**PA-2017-00978**  
**232 Nutley**

**Packet information submitted at the  
October 10, 2017 PC Meeting**

**PLANNING ACTION:** PA-2017-00978

**ASHLAND PLANNING DEPARTMENT  
STAFF REPORT**

A "PARKING  
SPACE" WITH  
NO WHERE  
TO GO

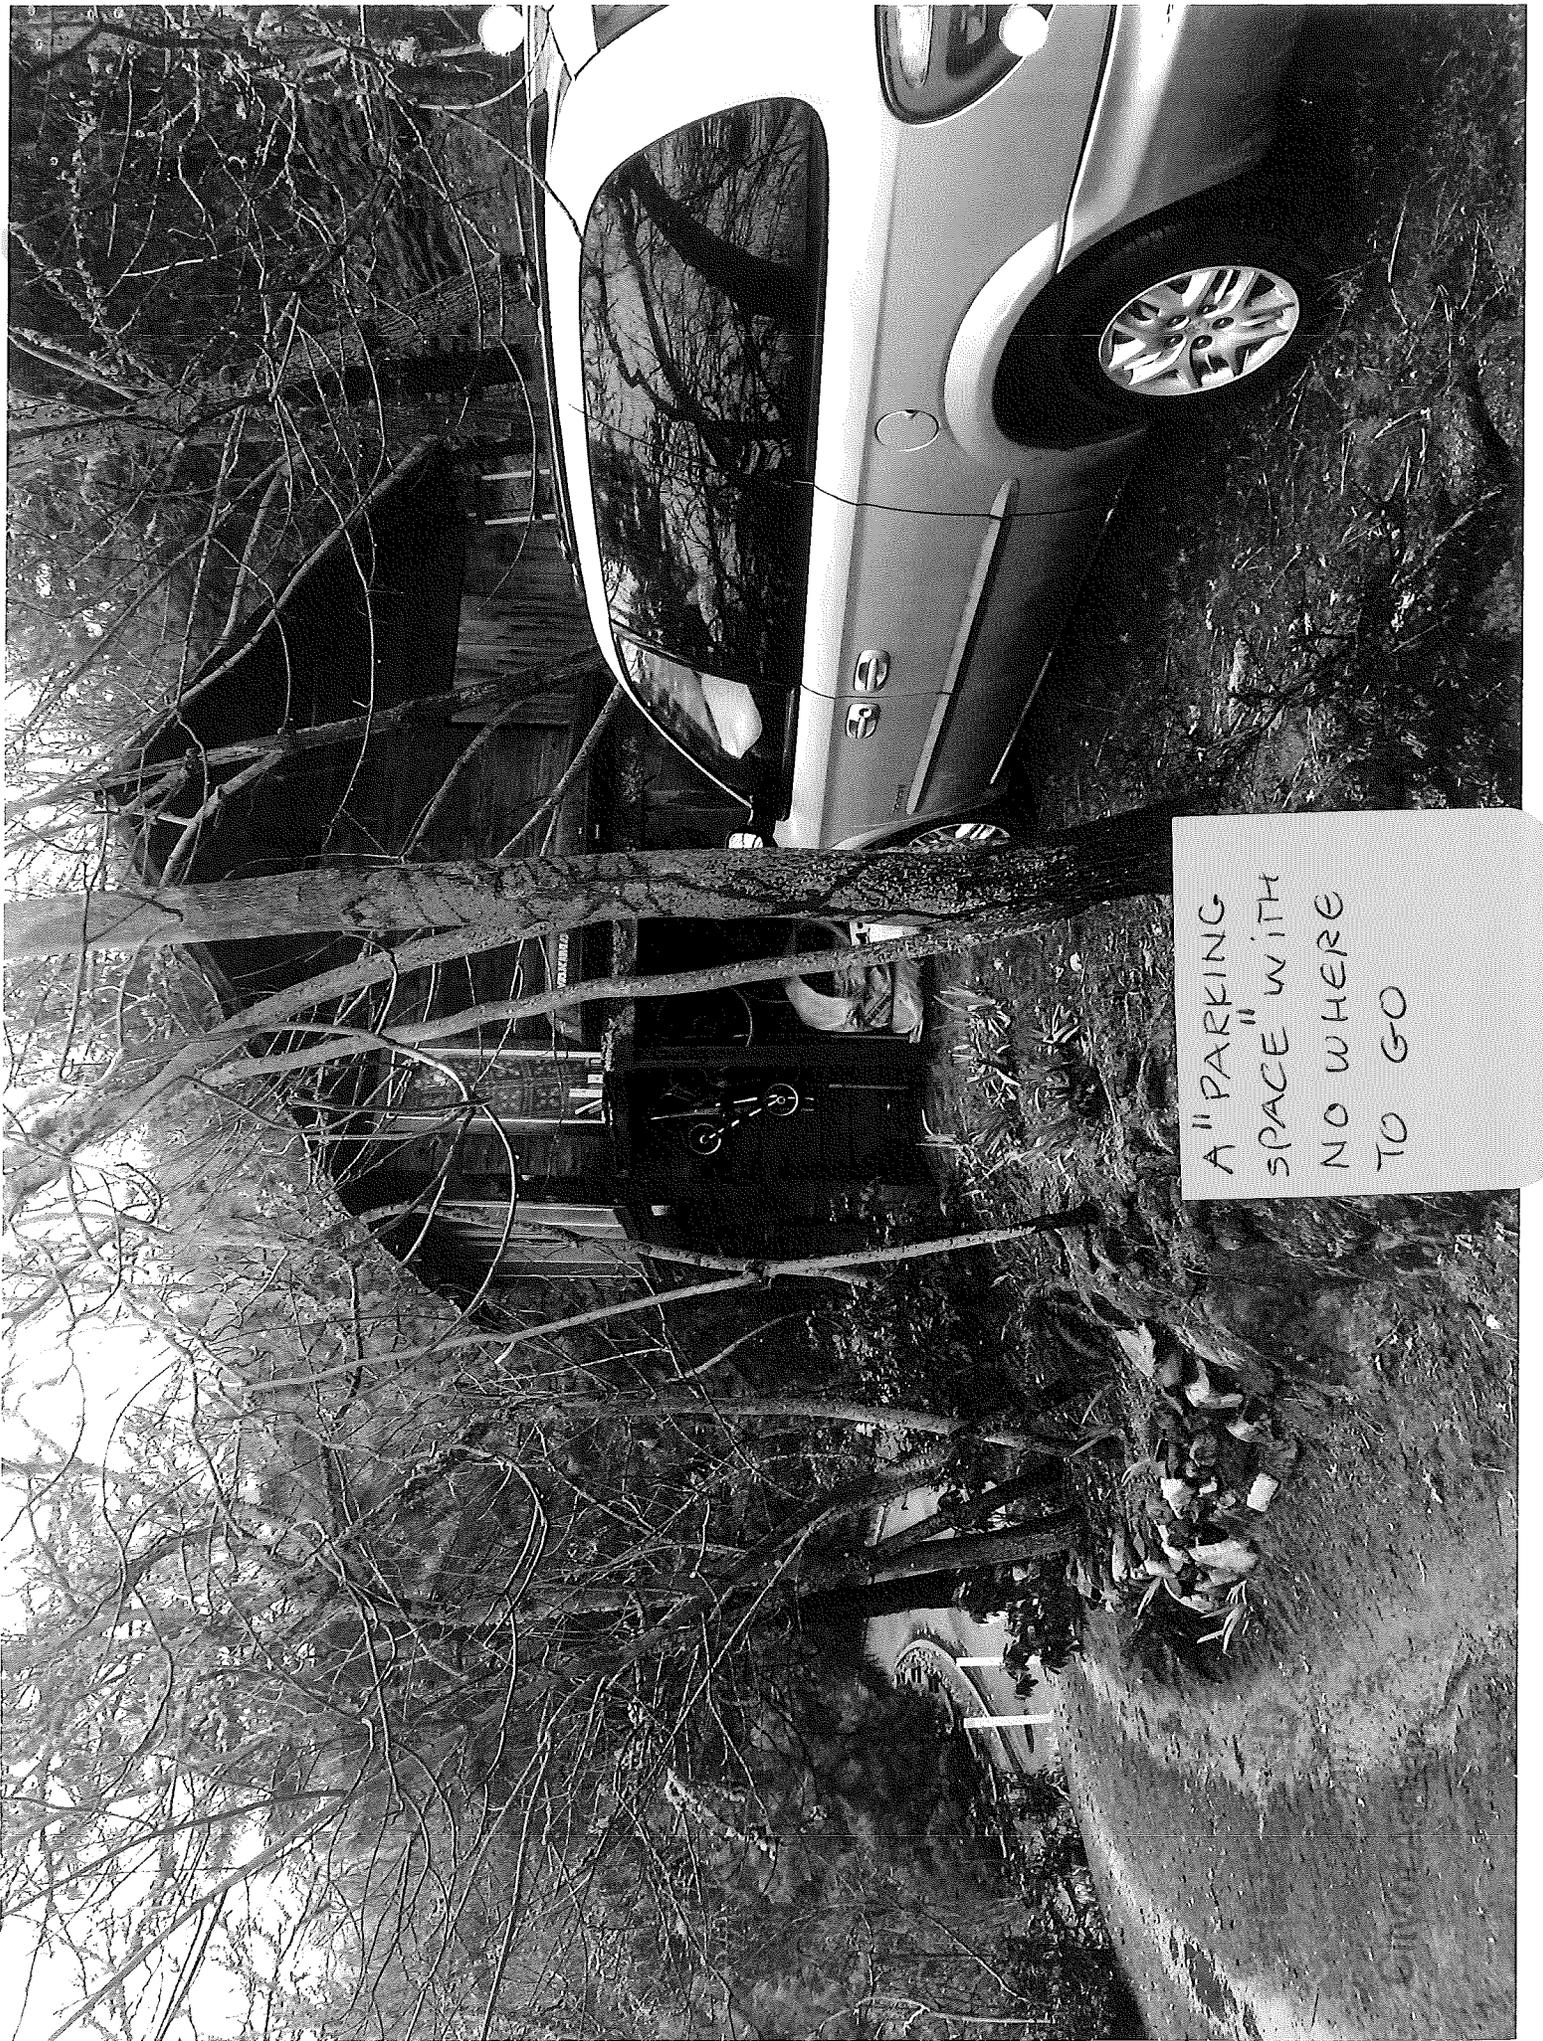
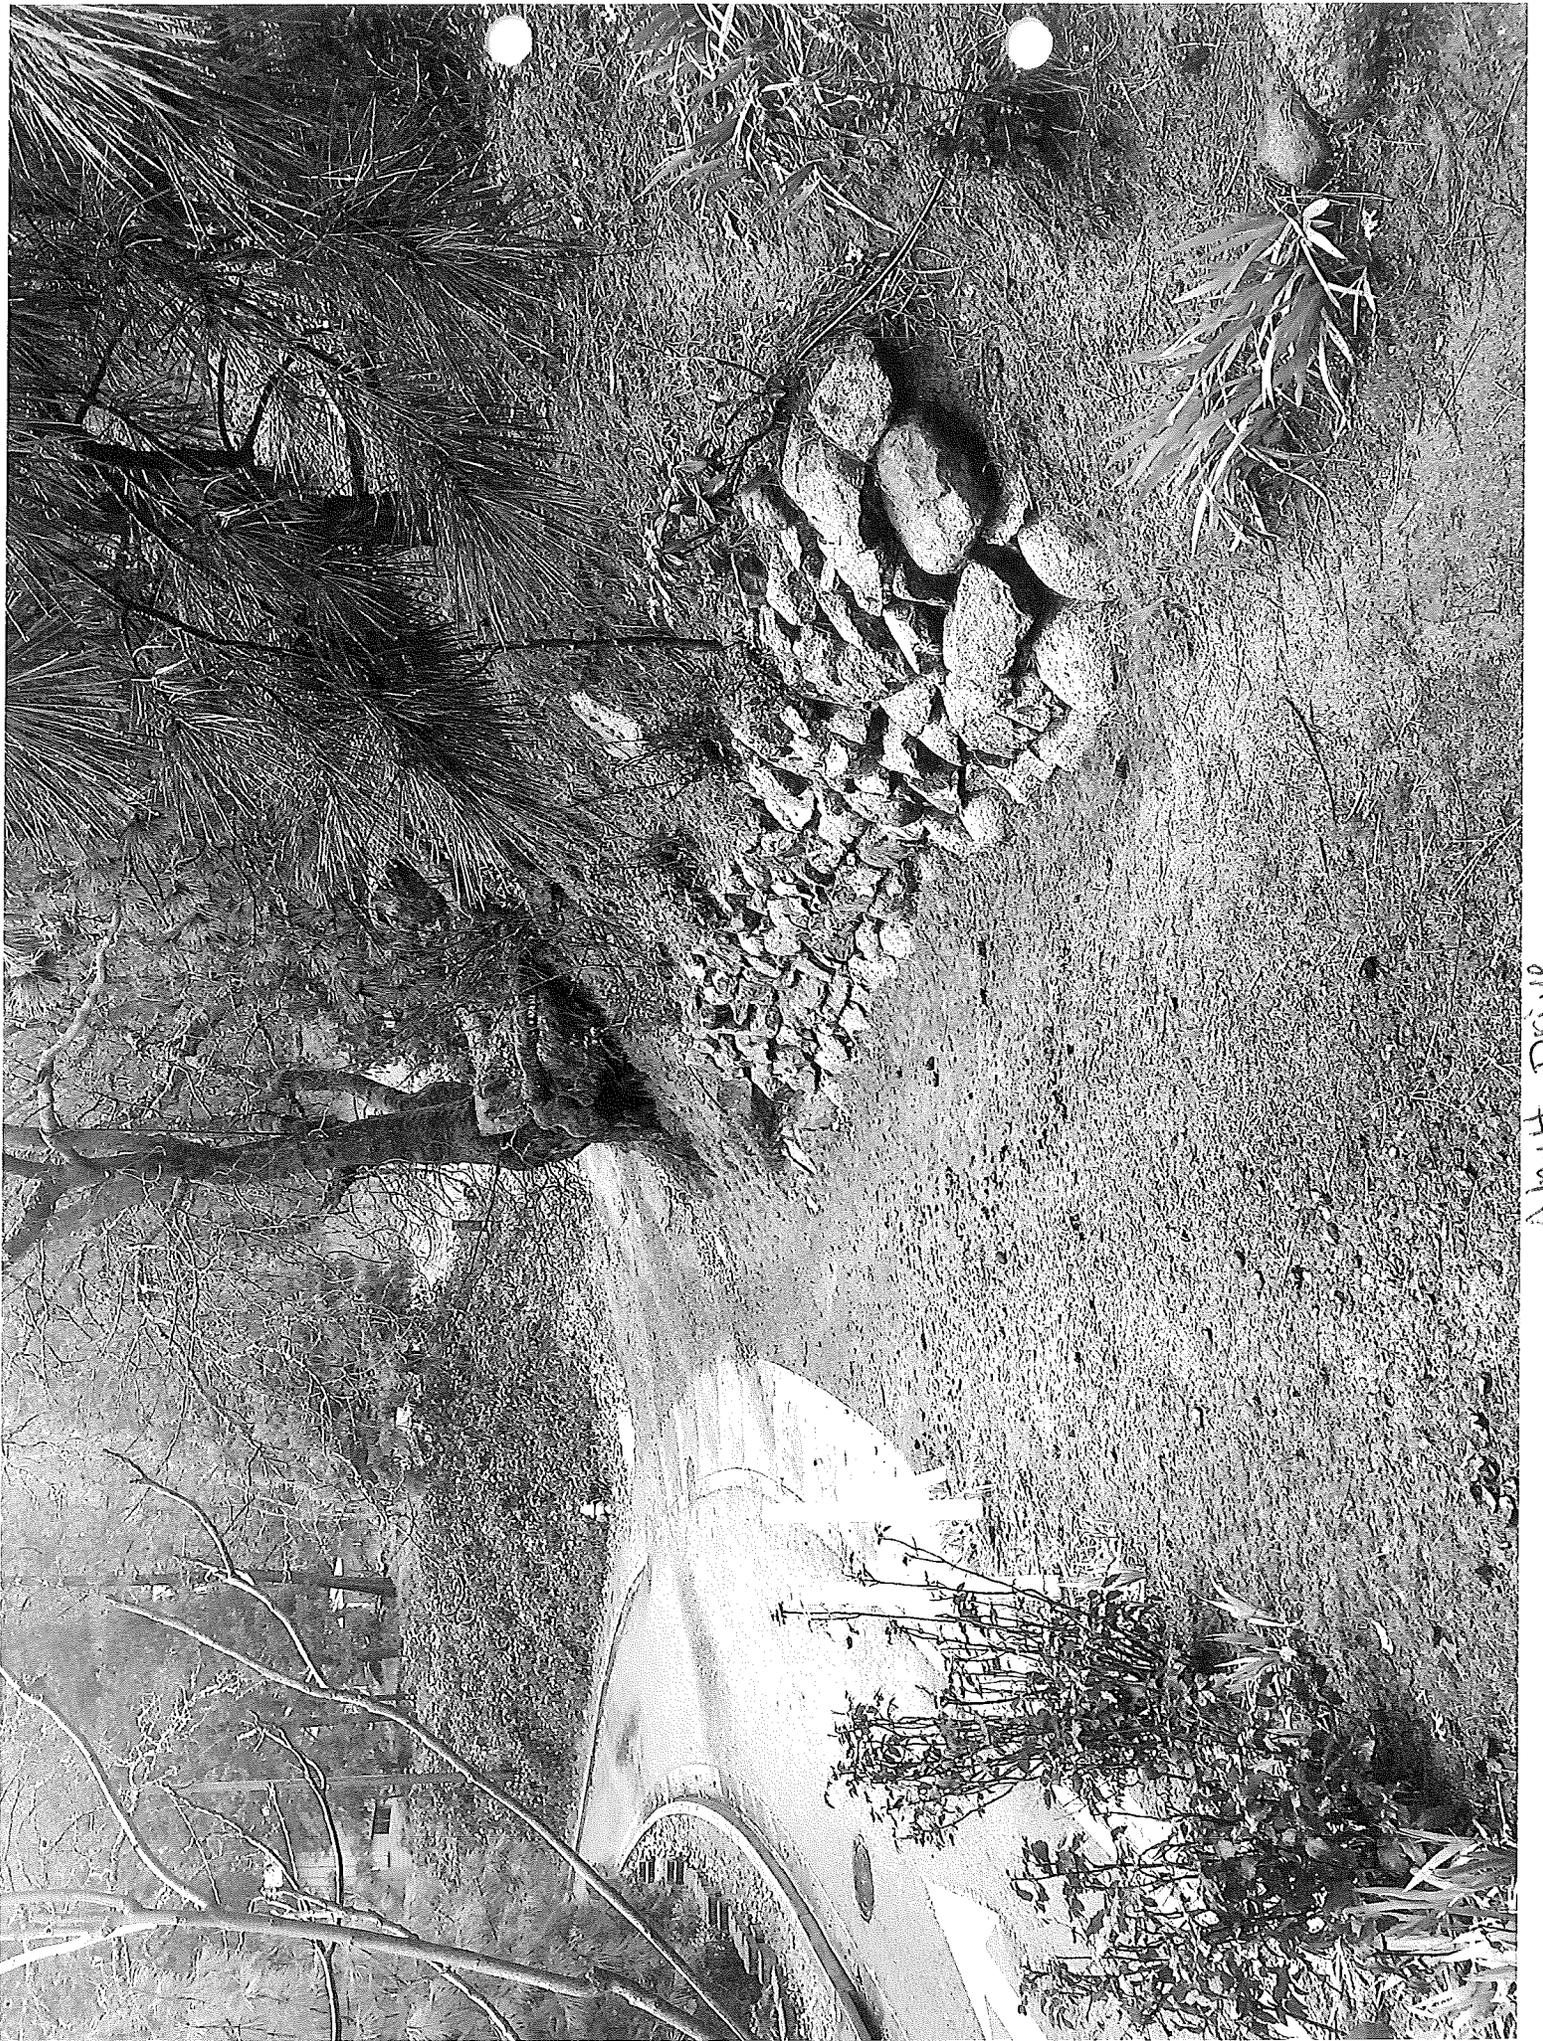
AREA OF  
CONVERGING APRONS  
FOR 151 ALNUTY  
AND THE PROPOSED  
ARU'S EXIT

AREA OF  
CONVERGING APRONS  
FOR 151 ALNUTT  
AND THE PROPOSED  
ARU'S EXIT

A "PARKING  
SPACE" WITH  
NO WHERE  
TO GO
